# Access Compliance Report

## Public Rights-of-Way

### (Curb Ramps)

Intersection ID: 10030537	Main Street: LITTLE ROCK RD	Cross Street: N/A	Location:	N
ADA ID: 2DE3A5DA409A	Ramp Type: BlendTrans2	Initial Pass/Fail: Fail	Overall Compliance: No	Severity Score: 10

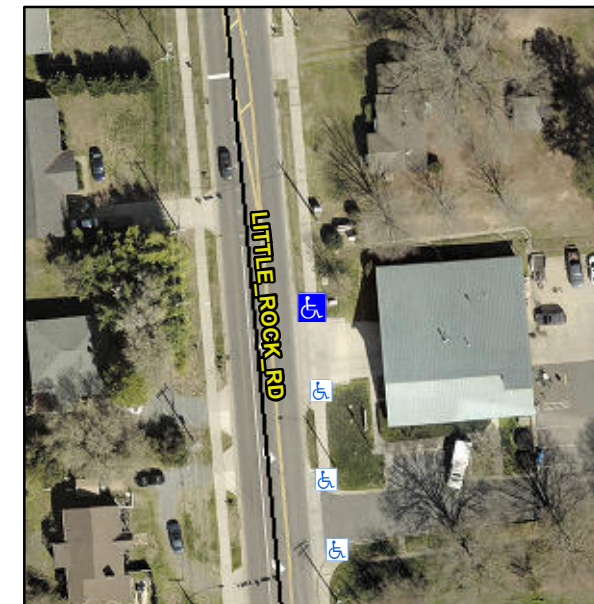
**Not Found, R304.5.1, R304.5.3**

Compliance	Description	Data	Compliance	Description	Data
N/A	Ramp Length (in)	75.0	Yes	BlendTrans Slope (%)	4.5
No	Ramp Width (in)	47.0	No	BlendTrans XSlope (%)	2.6
N/A	Flare Type LT	N/A	N/A	Flare Type RT	N/A
N/A	Flare Slope LT (%)	N/A	N/A	Flare Slope RT (%)	N/A
N/A	Flare Traversable LT?	N/A	N/A	Flare Traversable RT?	N/A
N/A	Landing Length (in)	N/A	N/A	DWS Provided?	N/A
N/A	Landing Width (in)	N/A	N/A	DWS Contrast?	N/A
N/A	Landing Slope (%)	N/A	N/A	DWS Length (in)	N/A
N/A	Landing X Slope (%)	N/A	N/A	DWS Full Width?	N/A
N/A	Landing Curb? (Y/N)	N/A	N/A	DWS Offset (in)	N/A
N/A	Shared Landing?	N/A			
N/A	Gutter Ponding?	N/A	N/A	Gutter Slope (%)	N/A
N/A	Gutter Lip Ht (in)	N/A	N/A	Gutter X Slope (%)	N/A
N/A	Painted X Walk1?	No	N/A	Painted X Walk2?	No
	X Walk 1 Direction	To W		X Walk 2 Direction	To S
	X Walk 1 Width (in)	N/A		X Walk 2 Width (in)	N/A
	X Walk 1 Slope (%)	2.1		X Walk 2 Slope (%)	1.1
	X Walk 1 X Slope (%)	0.7		X Walk 2 X Slope (%)	3.5

N/A	Ramp inside XWalk1?	N/A	N/A	Ramp inside XWalk2?	N/A
	Road Slope (%)	0.8		Clear Space?	N/A
	Road X Slope (%)	2.7	N/A	Clear Space to XWalk (in)	N/A
N/A	Any Obstructions?	N/A	N/A	Storm Grate/Utility Hazard?	N/A
	Obstruction Type			Storm Grate/Utility Type	
		N/A			N/A
			Yes	Surface Condition? (G/P)	Good
			No	Curb Slope (%)	7.4

**Remove & Replace Curb Ramp With Two New Directional Ramps or Equivalent.**
